170 CLEAR SKY CIRCLE

April 10, 2006

RE: Liberty Lane Plan 1 - (Job #HS5092)  
Response to Request for Information  
Alternate Strap at Floor Framing

G:\Jobfiles\1\HS5092\Drawing Files\HS5092-p1.dwg, 4/6/2006 1:08:57 PM, NF

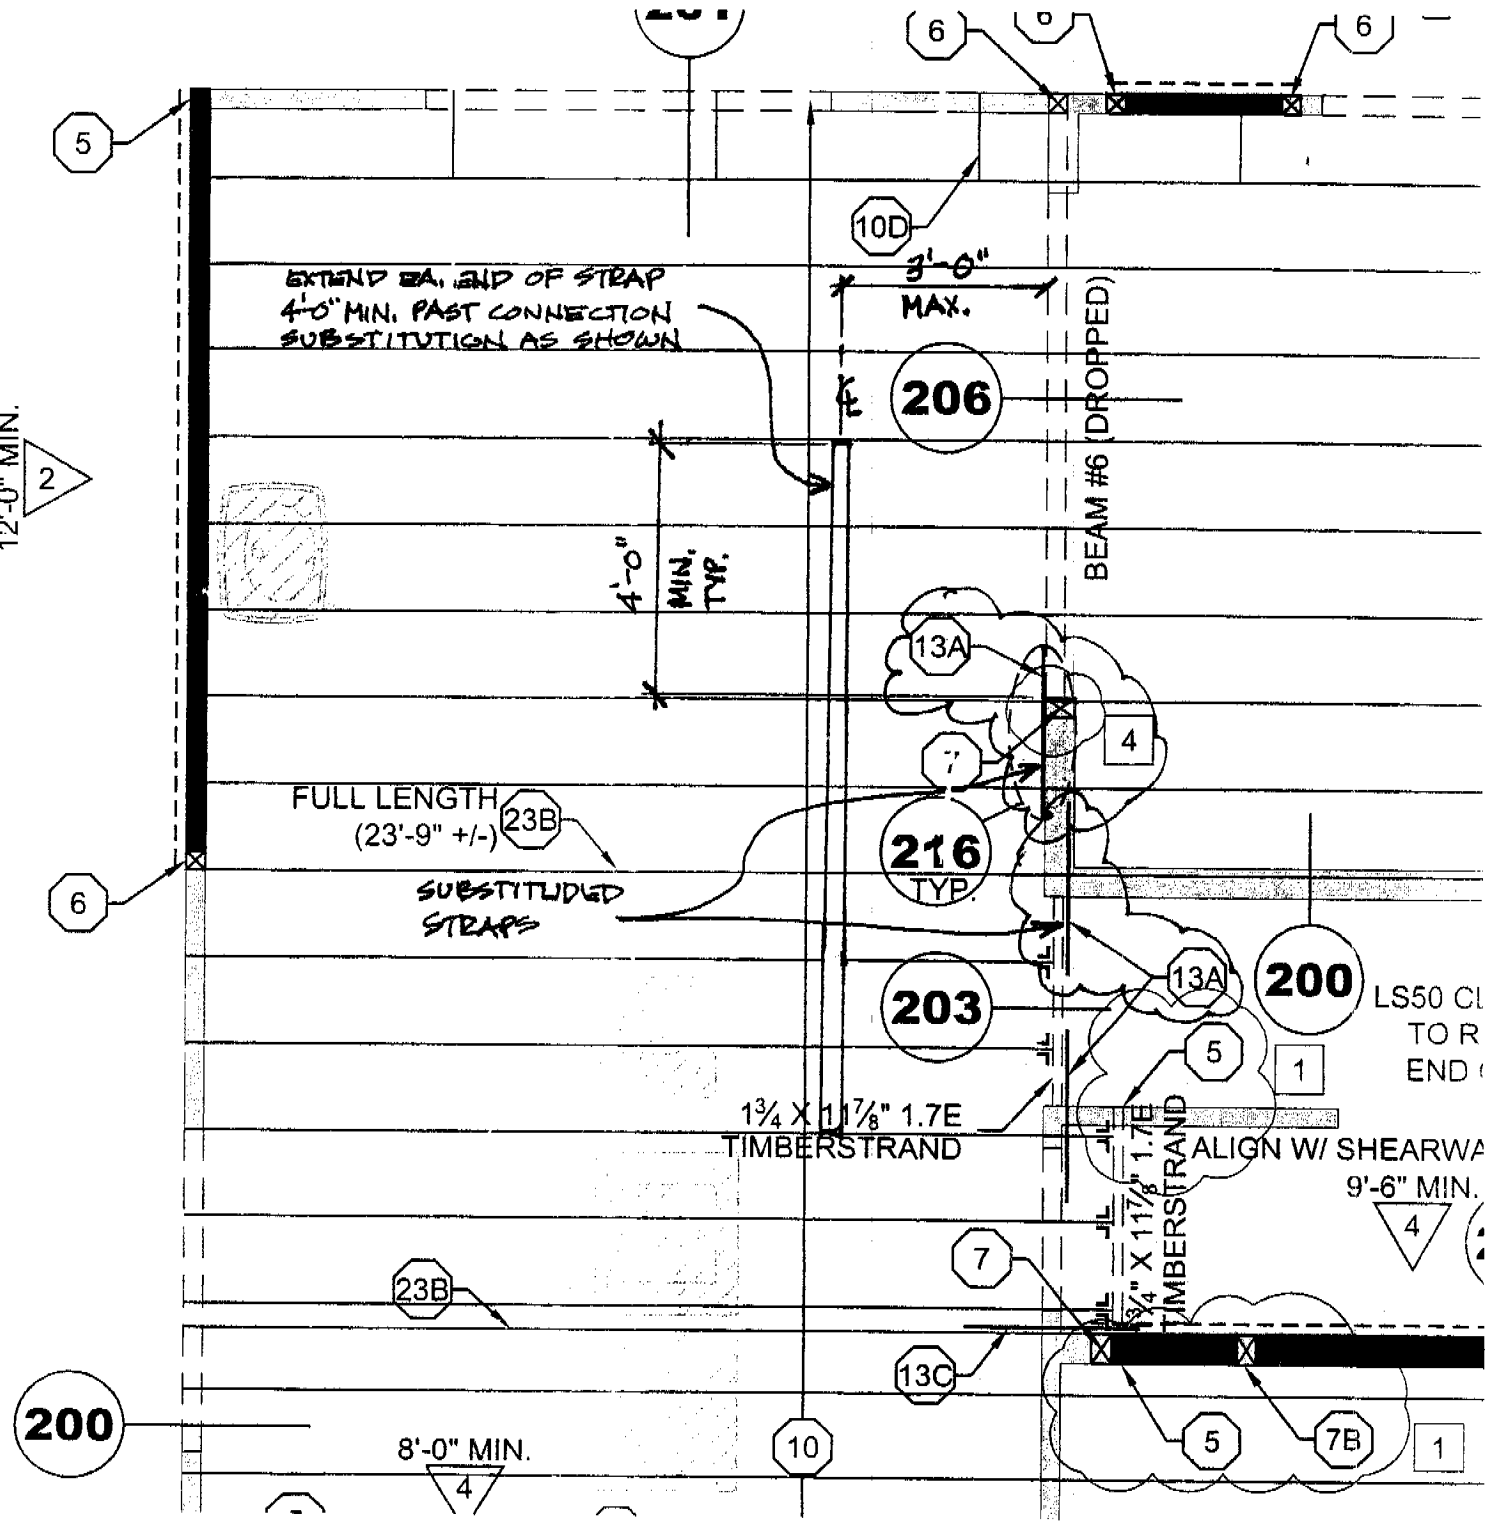
- The straps specified by keynote 13A, indicated on page 2, may be substituted either directly with a Simpson HTS20 strap, or with a Simpson CS16 strap placed over the floor sheathing, to blocking between the floor joists (see detail 217 on page 3). These straps are to be substituted where a plumbing pipe placed through the top plates have prohibited the installation of the straps specified on the plans.
